Product Bulletin:

TIREMAAX[®] Thermoplastic Tire Hoses

LIT NO: P56030

DATE: November 2015

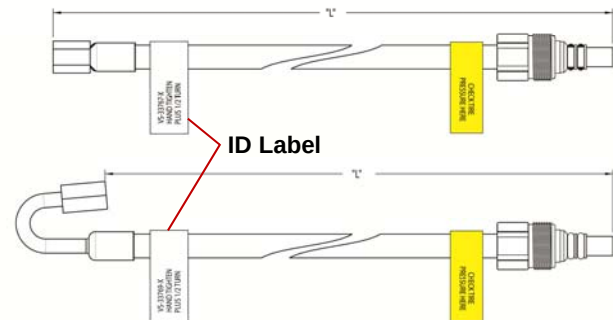
Hendrickson Trailer Commercial Vehicle Systems recently converted all new TIREMAAX[®] kits to thermoplastic tire hoses. In addition to converting the hose material, Hendrickson also added hose lengths to better address the wide variety of wheel combinations in the market. The below chart summarizes the thermoplastic tire hose part numbers by wheel combination, length, and identification label color.
